TECHNICAL NOTE

Job Name: Tollgate Road, Colney Heath
Job No: 332510999
Note No: TN001
Date: 24 January 2023
Prepared By: Åsa Söderberg
Subject: **Response to Resident Objection, dated 16 and 17 January 2023 (planning application reference 5/2022/1988)**

Figure 2 – Borehole and trial pit locations

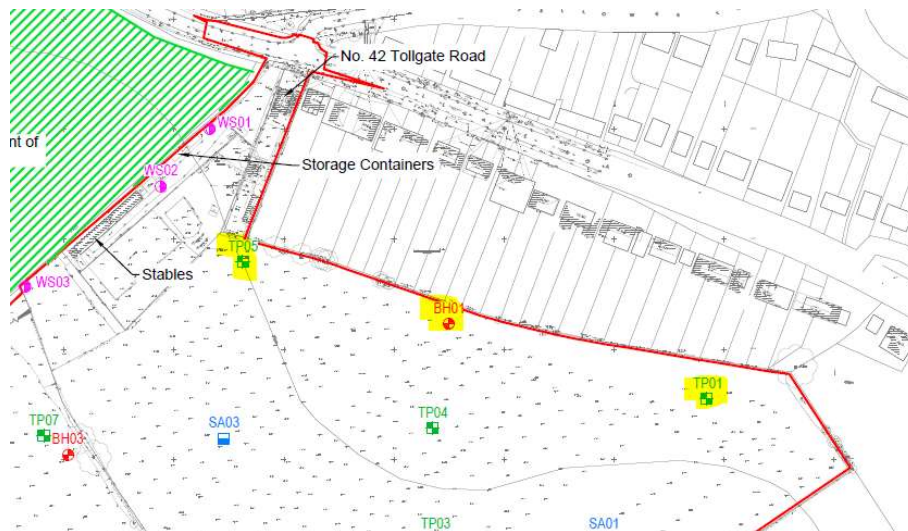
The geology present at the site is not typical of where underground/ subterranean river – or ‘winterbourne rivers’ as they are sometimes referred – would form. The geological sequence along that northern boundary (BH01, TP01 and TP05, see location plan in Figure 2 below) indicates the presence of the following sequence:

- BH01 Kesgrave Sub Group – gravel dominated (1.3m thick) over clay dominated Kesgrave (3.1m thick) over Diamicton Till
- TP01 Kesgrave Clay (0.55m thick) kesgrave sand (1.65m) over Kesgrave Clay (unproven depth)
- TP05 Kesgrave Sand (1.45m) over Kesgrave sandy clay (unproven depth)

The location of the borehole and trial pits coincide with the area shown in Figure 1 shown to be at risk of surface water flooding.

In even lightly wet weather, surface water could easily pool in a shallow topographical depression such as this and realistically has nowhere to go until it can roll downhill or permeate into the sub ground.
